STAFF RECOMMENDATION 1310 Seventh Avenue North November 18, 2015

Application: Demolition—outbuilding; New construction—infill
District: Germantown Historic Preservation Zoning Overlay
Council District: 19
Map and Parcel Number: 08209003100
Applicant: John Root, Architect
Project Lead: Melissa Baldock, melissa.baldock@nashville.gov

Description of Project: Application is to demolish an outbuilding and construct new infill.

Figure 1. The primary and accessory structures at 1310 Seventh Avenue North.

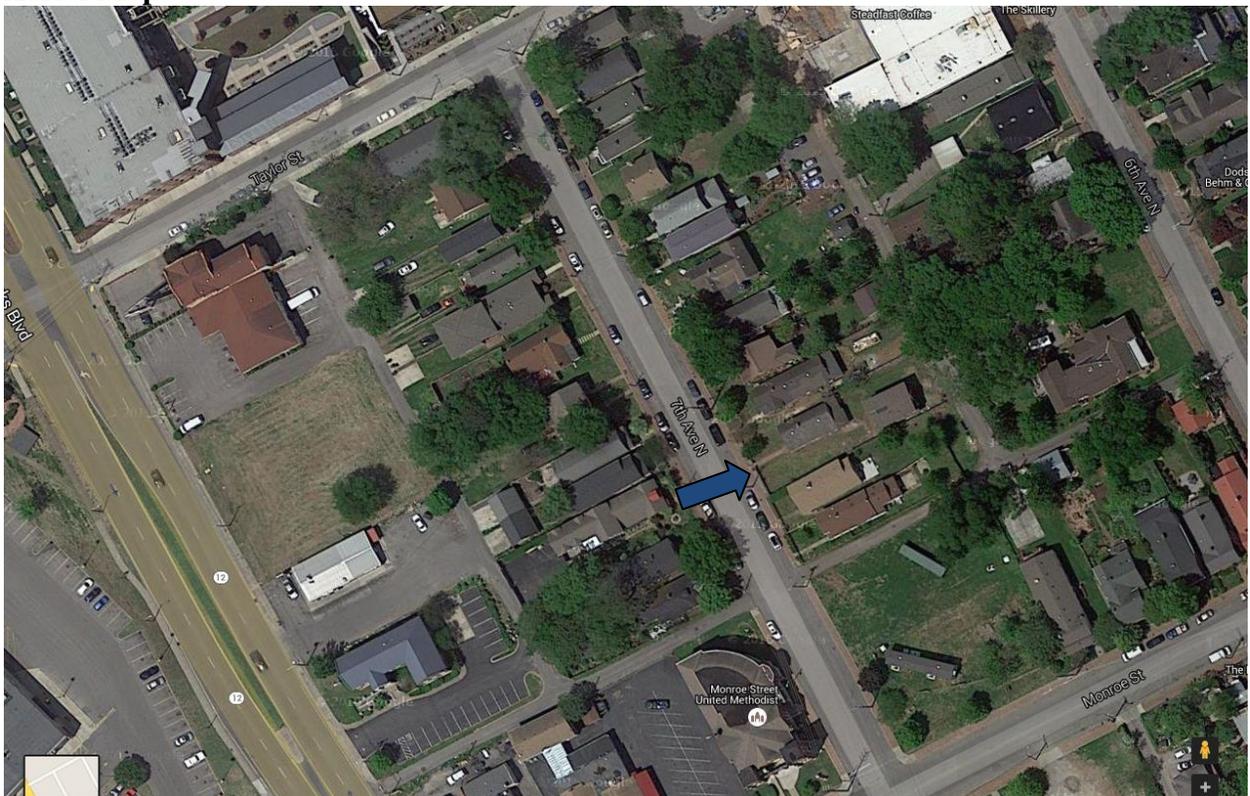
Demolition: The application involves the demolition of an outbuilding (See Figure 1). The date of construction of the outbuilding is not known, but it does not appear on the 1957 Sanborn map and appears to have been constructed without a building permit. The outbuilding's materials, size, roof form, and design do not contribute to the historic character of the site or the overall neighborhood, and staff finds that its demolition meets Section 7.0 of the design guidelines.

SITE PLAN

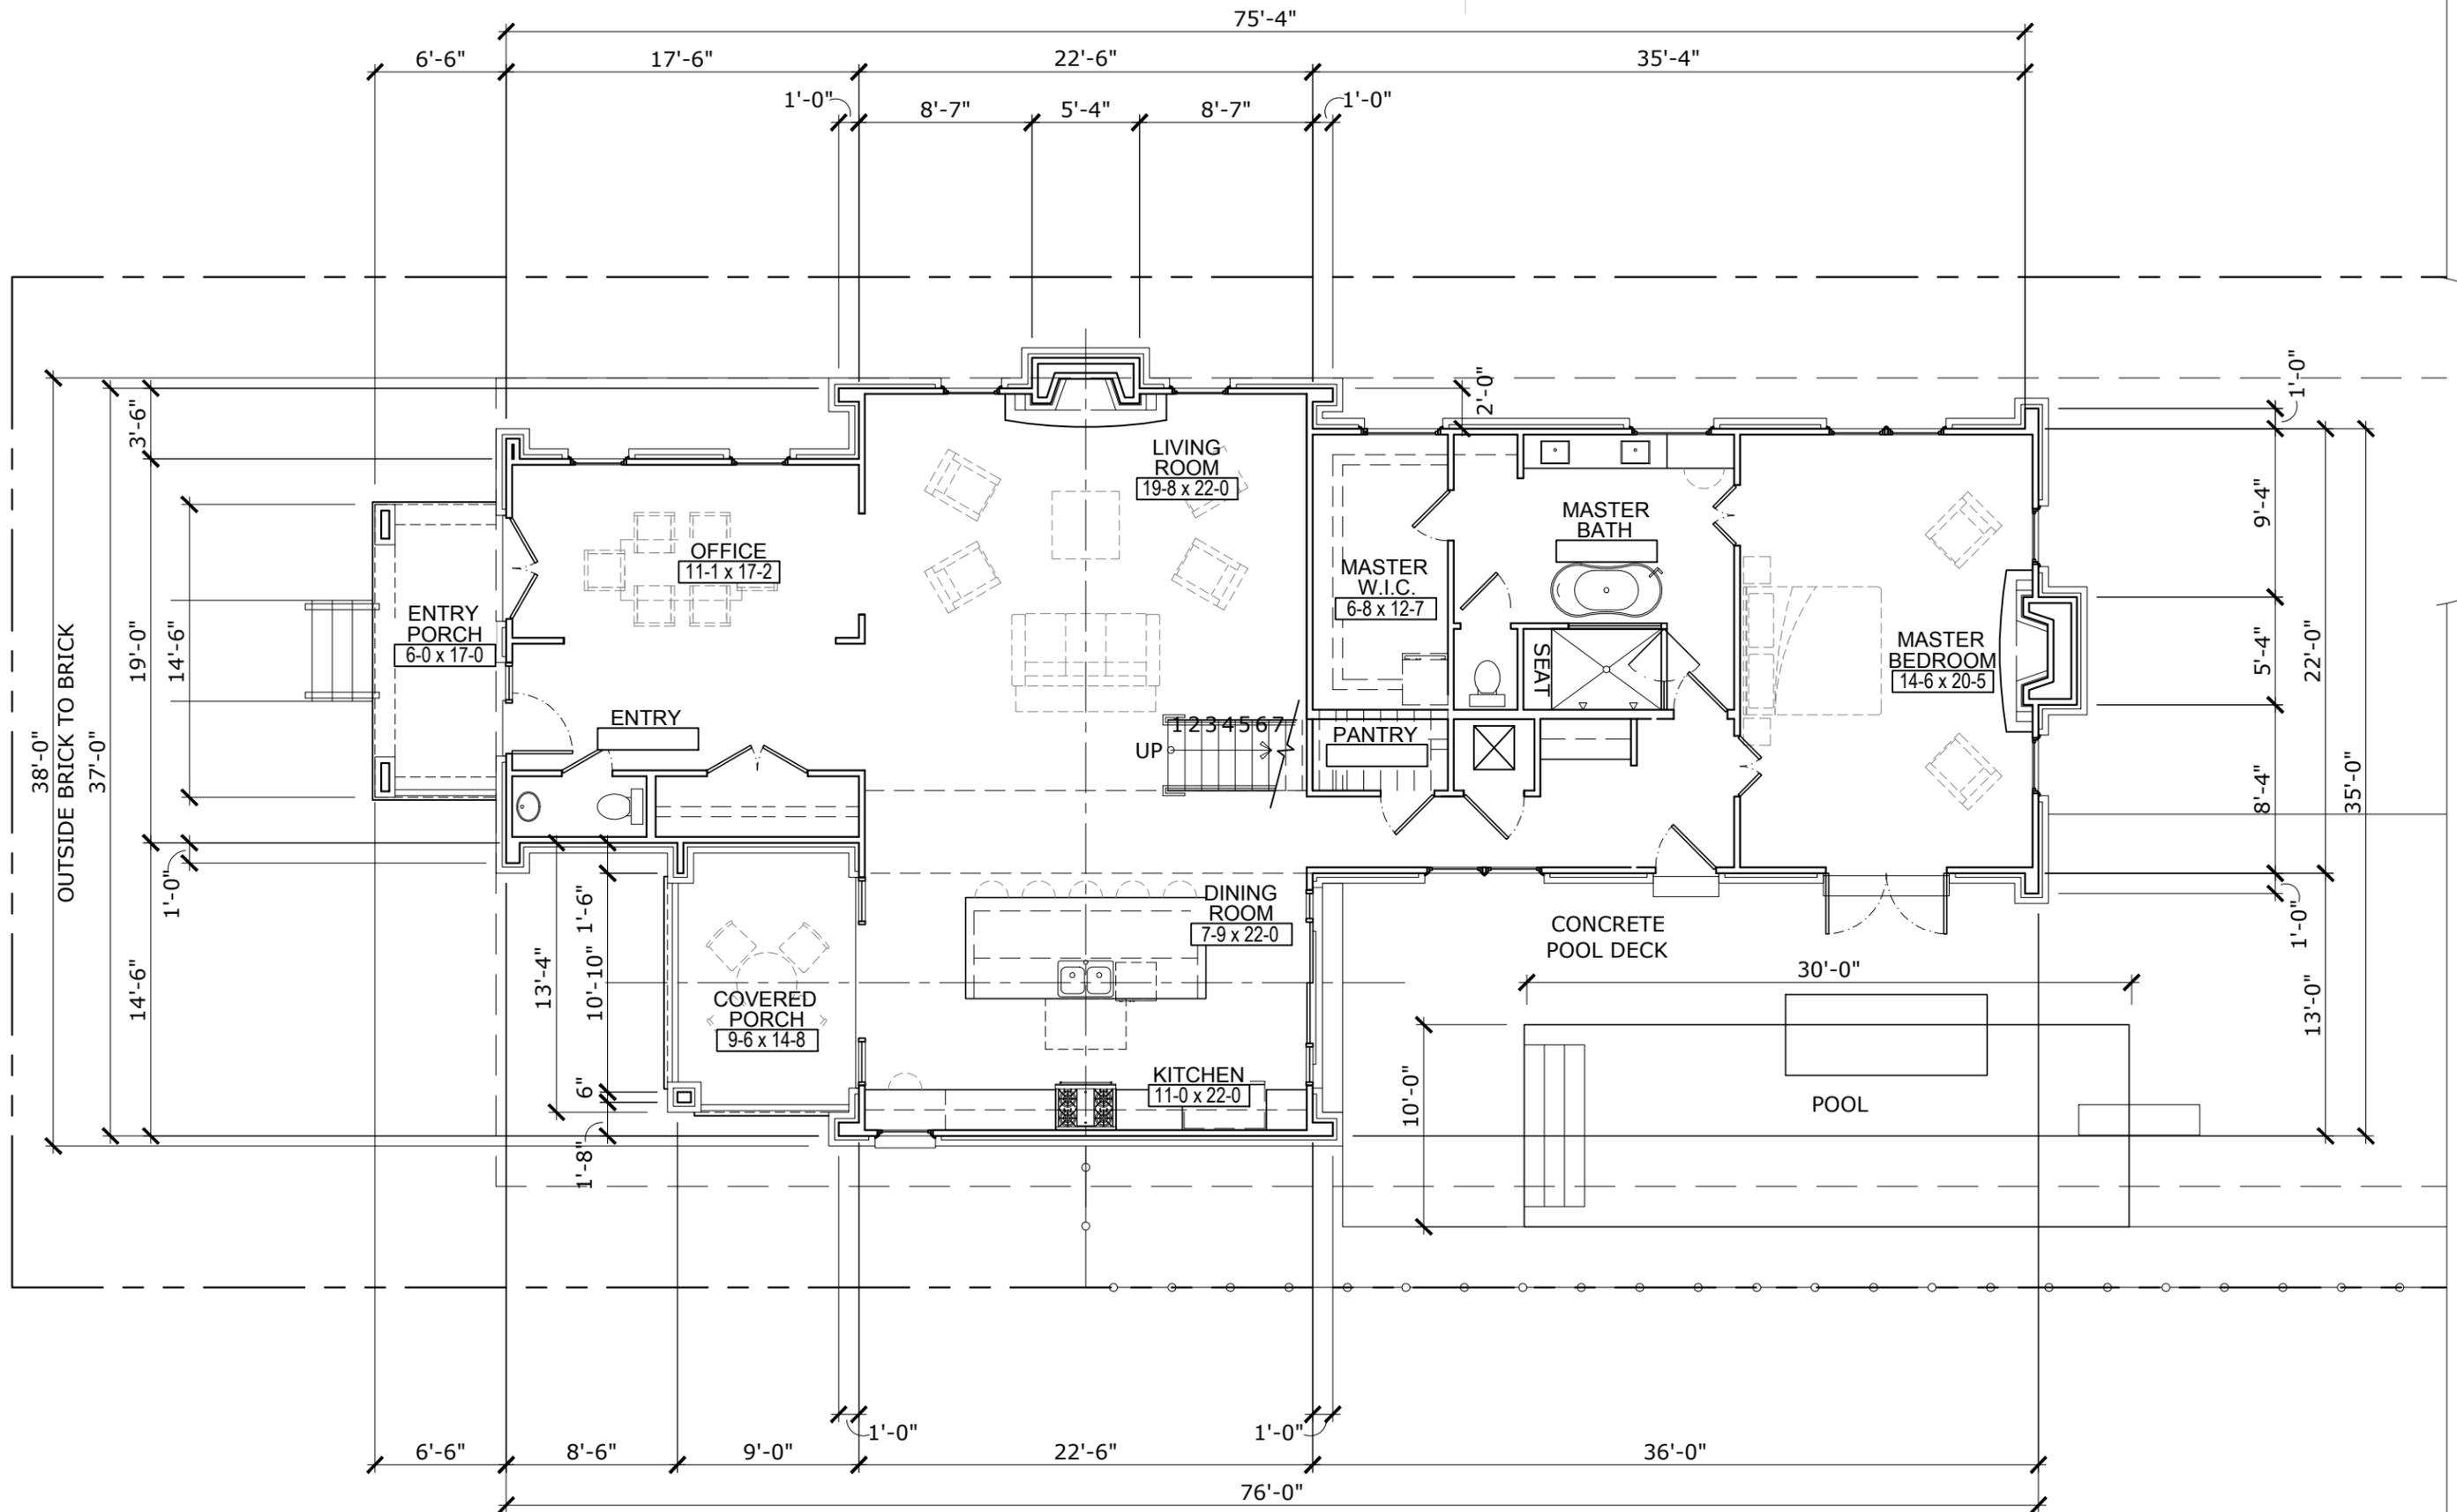
Utilities/Mechanical. No location for the mechanicals and utilities were indicated on the site plan, and staff recommends that they be placed at the rear, or on a side façade behind the midpoint of the house.

Fences, walls, and other appurtenances. The site plan indicates that a six foot (6') wood privacy fence will be installed from the midpoint of the infill to fence in the rear yard. Staff finds this to be appropriate. A four foot tall (4') aluminum fence will be installed in the rear yard around the pool, and within the perimeter of the six foot (6') privacy fence. If approved, Staff recommends approval of the pool fence design prior to purchase and installation. Staff also recommends approval of the patio and pool deck pavers and any other site features to ensure that they comply with Section 5.1 of the design guidelines.
